ADDENDUM NUMBER 1
TO THE DRAWINGS AND SPECIFICATIONS

PROJECT: McLean County Unit District No. 5 Oakdale Elementary School Restroom

Renovation – Phase Two

A/E PROJECT NO: 26452323

1. TO THE DRAWINGS SHEET, ME-1, First Floor Mechanical Plan:

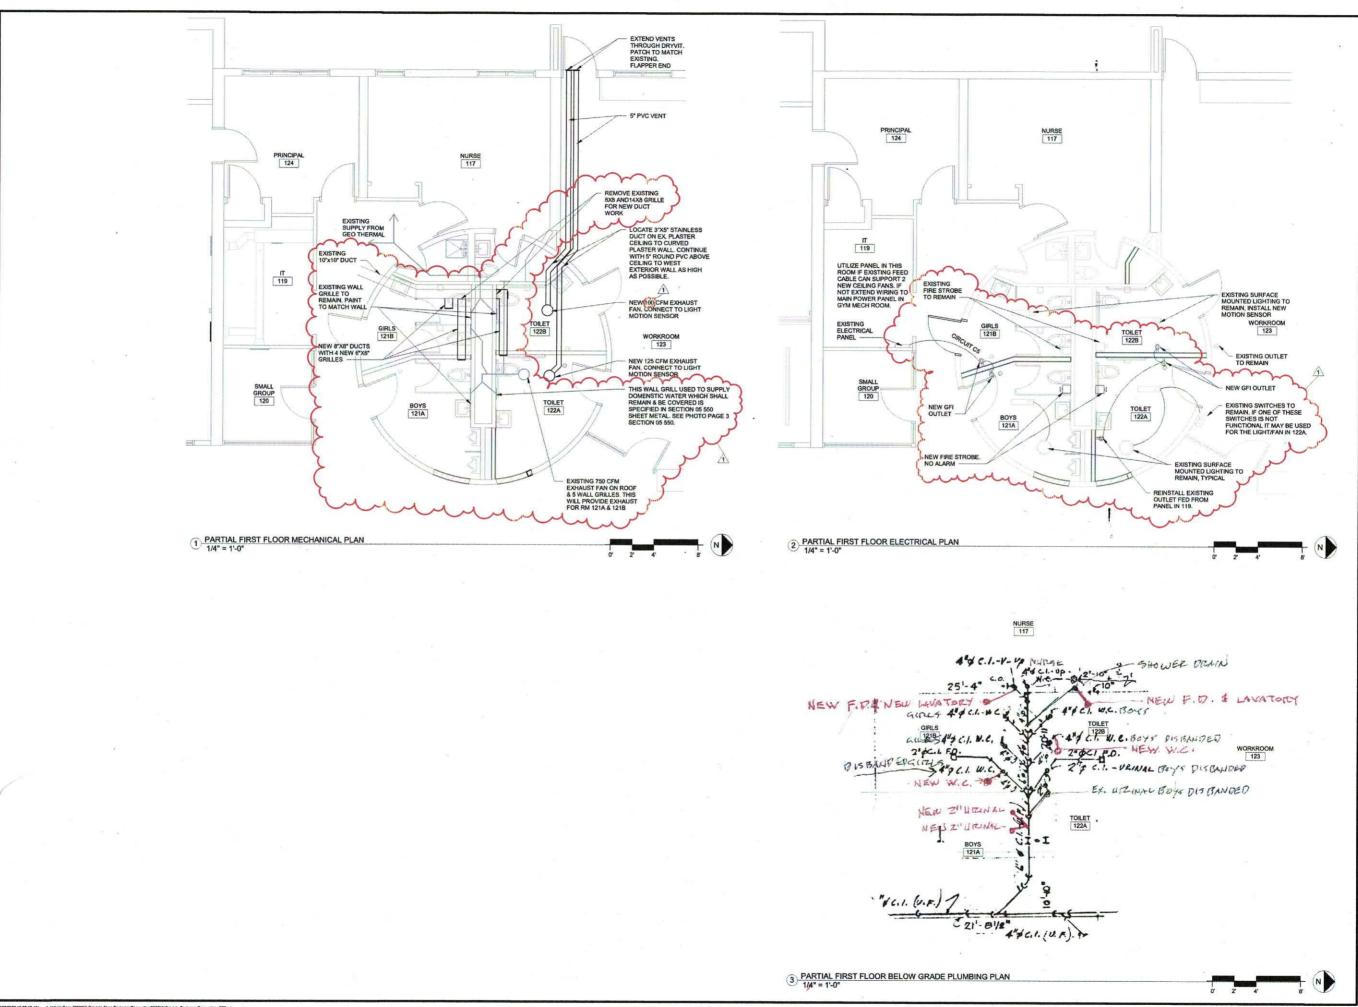
- a. The lower opening in south wall of new room 122 which was a return grill is now used as a penetration point for hot and cold domestic water. The water pipes shall remain. The opening should be closed off with paint grip sheet metal as good as possible.
- b. The 10" x 10" duct provides conditioned air to the present rooms 121 and 122. Modify this duct as shown on drawing to provide conditioned air to the four rooms 121A, 121B, 122A, and 122B.
- c. The new exhaust fan for room 122B is shown on issued plan to be 750 cfm. Change this to be 100 cfm.
- d. In room 121B, there is a damaged thermostat on the south wall. Remove this unit and patch wall. This thermostat is not operational.

- a. The two existing Fire Strobe alarms will be used in the room where they are presently located. Two new Fire Strobe alarms (no audible alarm) shall be installed one in each room 121A and 122A.
- b. In each room 121A, 121B, 122A, and 122B add Ground Fault Intercept outlets as shown. The three GFI's shown in Rooms 122A and 122B shall be powered from existing outlet relocated as shown. The two GFI's in rooms 121A and 121B may be powered from the panel in room 119 circuit C5.
